SERVICE BULLETIN

N° **189-382**

ATA 71 - FUEL AND D1 DRAINAGE LINES INSPECTION

Figure 1

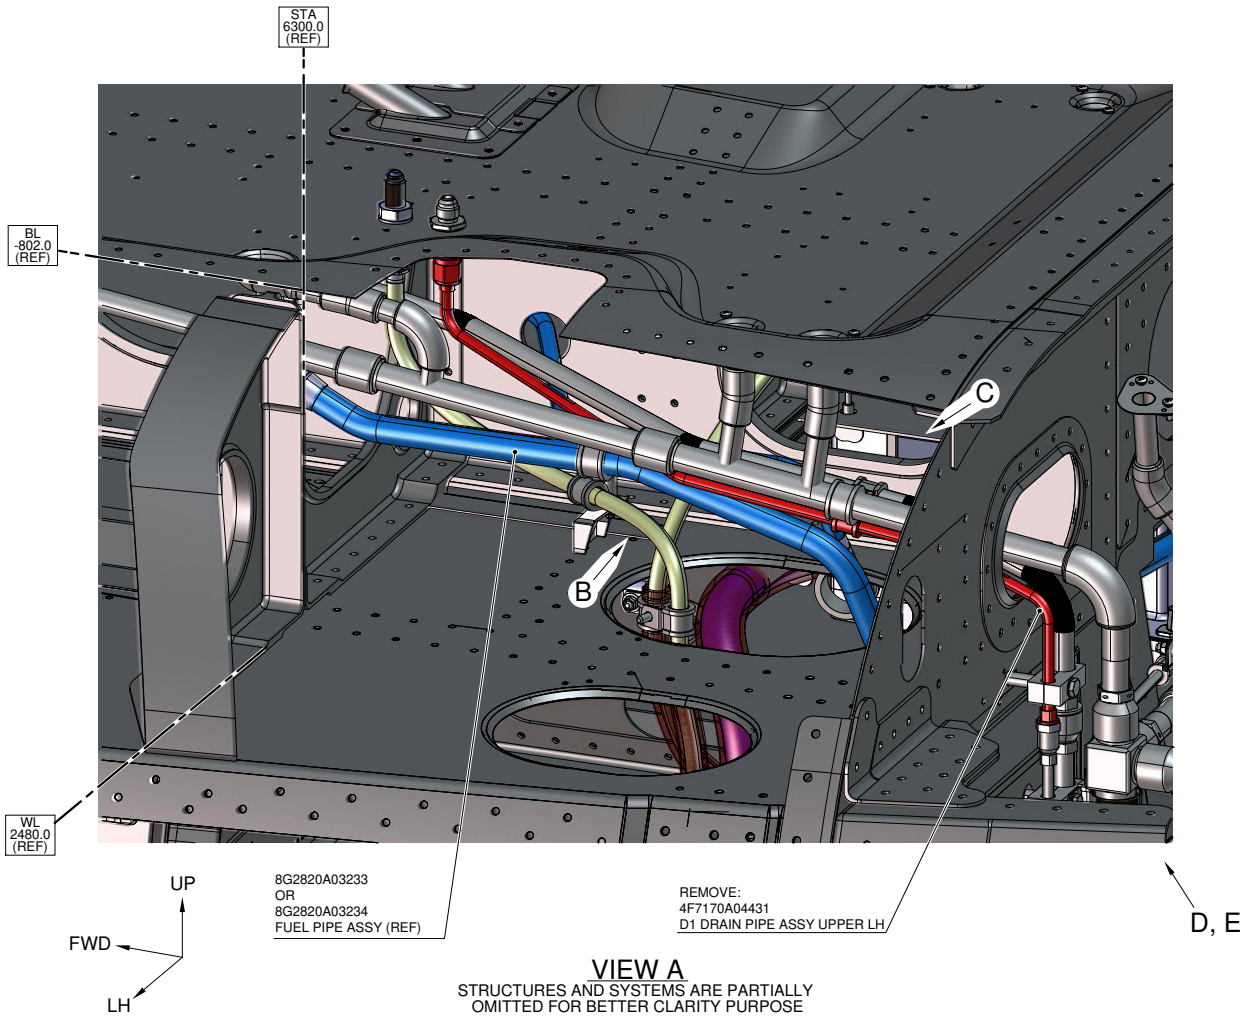
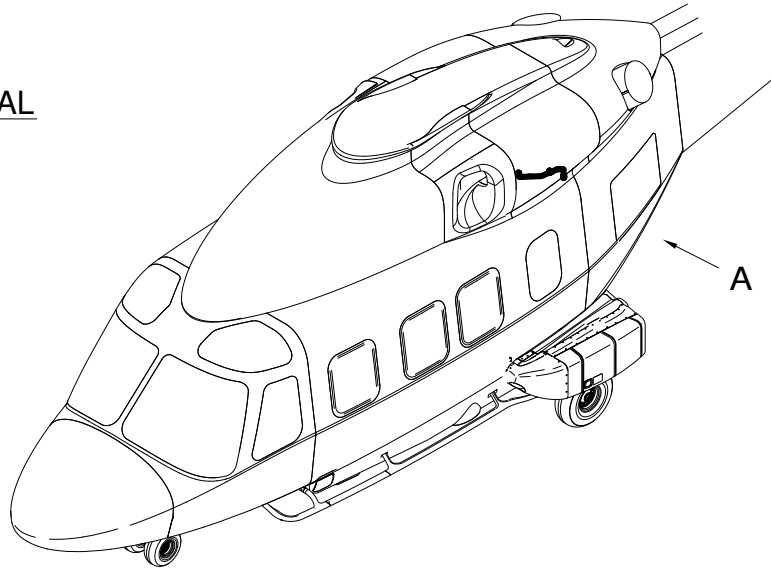
3. With reference to Figure 1 and Figure 2 View B, using a borescope and a bright light source, visually inspect the whole zone of intersection between the “D1 drain pipe assy upper LH” P/N 4F7170A04431 and the fuel pipe assy P/N 8G2820A03234 or P/N 8G2820A03233, for evidence of chafing. In case of no findings, skip to Step 6. Otherwise, perform the following Step.
4. In case of damage on “D1 drain pipe assy upper LH” P/N 4F7170A04431 only, no action is required. Proceed to Step 6.
5. In case of damage on fuel pipe assy P/N 8G2820A03234 or P/N 8G2820A03233, perform the following procedure:
 - 5.1 Measure the depth of the damage found. Use the borescope with measurement feature. Take a picture of the damaged pipe and fill the report in Figure 4. Send pictures and report to Leonardo Helicopters at the following mail box: engineering.support.lhd@leonardo.com.

- 4.1 With reference to Figure 1, using a bright light source, visually inspect the fuel pipe assy for evidence of damage.
 - 4.2 In case of findings, take a picture of the damaged pipe and fill the report in Figure 4. Send pictures and report to Leonardo Helicopters at the following mail box: engineering.support.lhd@leonardo.com. Then perform Step 5.

VIEW B

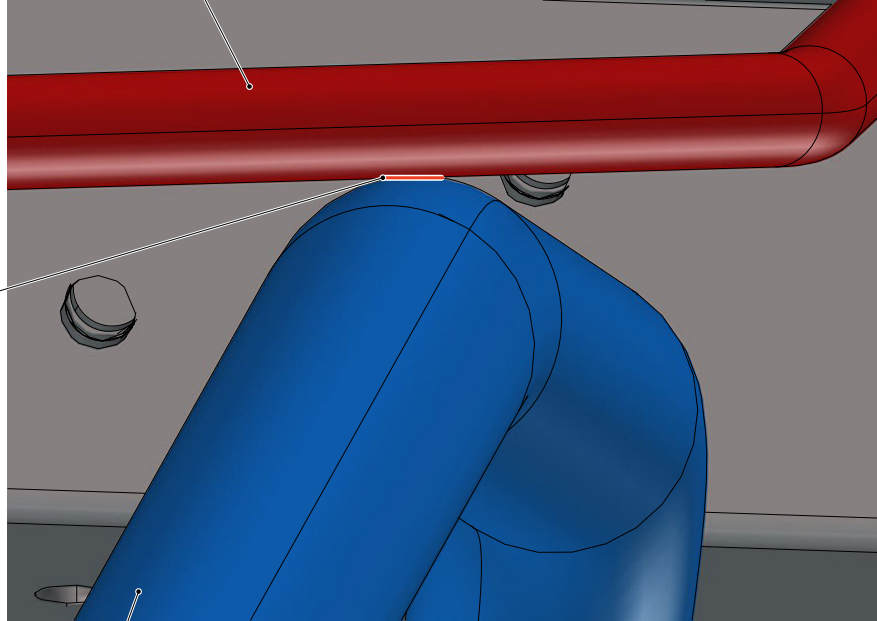
CHAFING

Figure 2

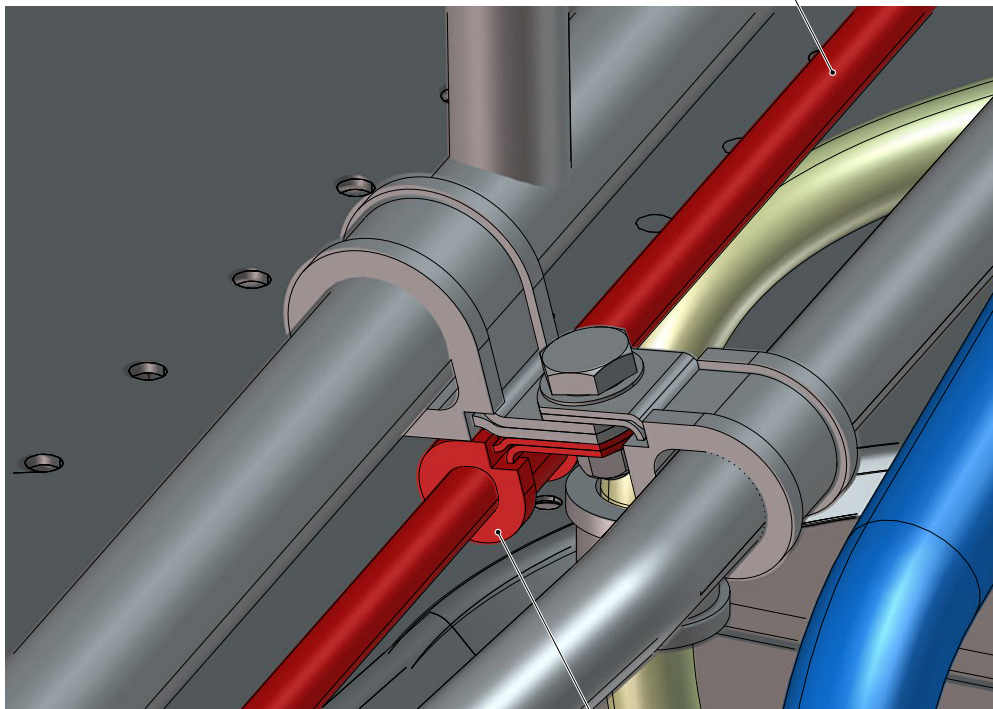
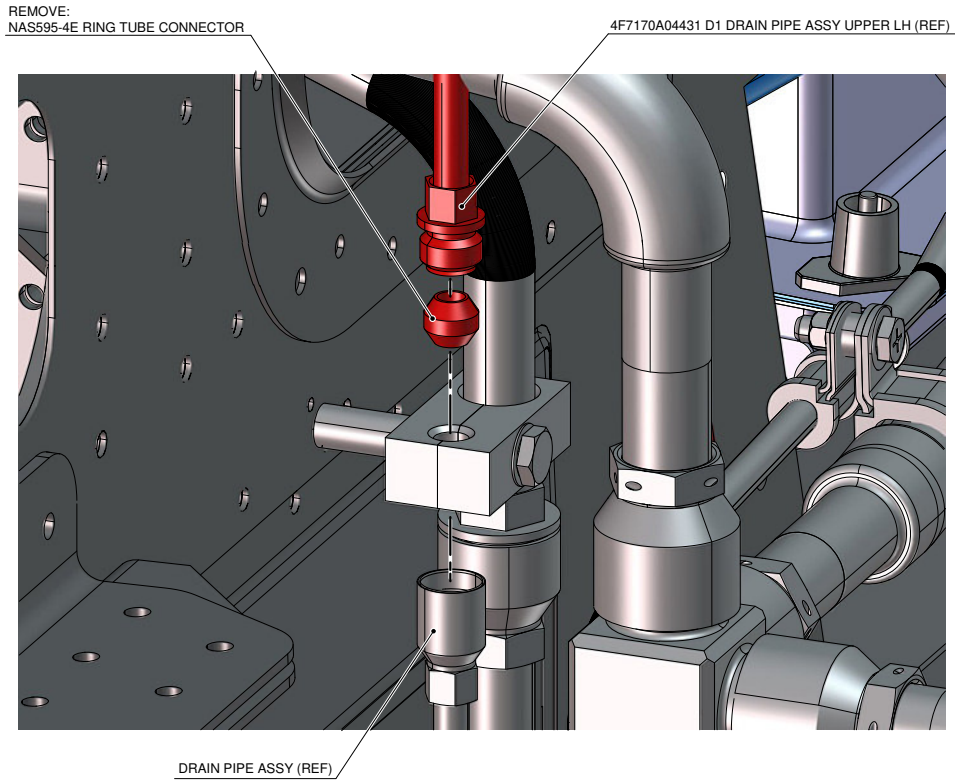
- 5.2.1 With reference to Figure 2 View C, remove the clamp P/N AS21919WCH04 from the “D1 drain pipe assy upper LH” P/N 4F7170A04431.
 - 5.2.2 With reference to Figure 1 thru 3, remove the “D1 drain pipe assy upper LH” P/N 4F7170A04431 and the ring tube connector P/N NAS595-4E.

3. If not already removed, perform the engine drain D1 retromod removal P/N 8G7170P00311 as described in the following procedure:
 - 3.1 With reference to Figure 2 View C, remove the clamp P/N AS21919WCH04 from the D1 drain pipe assy upper LH P/N 4F7170A04431.

REMOVE:
AS21919WCH04 CLAMP

Figure 3

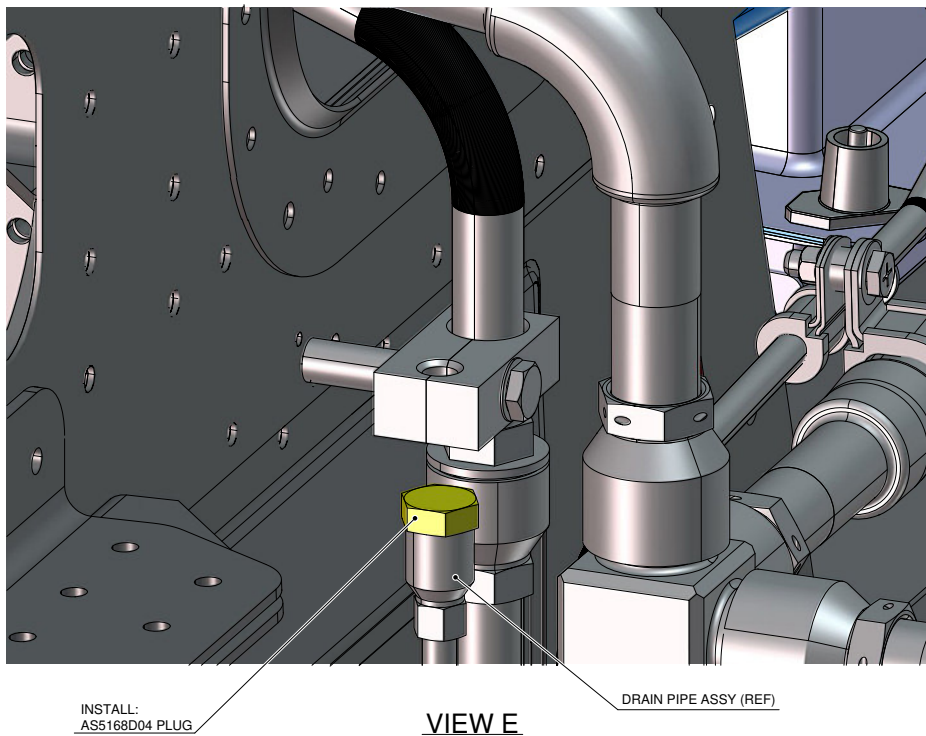
- 5.2.3 With reference to Figure 3 View E, install the plug P/N AS5168D04. Then skip to Step 6.
- 5.3 If the damage depth is more than 0.4 mm perform Part II of this SB.

- 3.2 With reference to Figures 1 thru 3, remove the "D1 drain pipe assy upper LH" P/N 4F7170A04431 and the ring tube connector P/N NAS595-4E.
 - 3.3 With reference to Figure 3 View E, install the plug P/N AS5168D04.
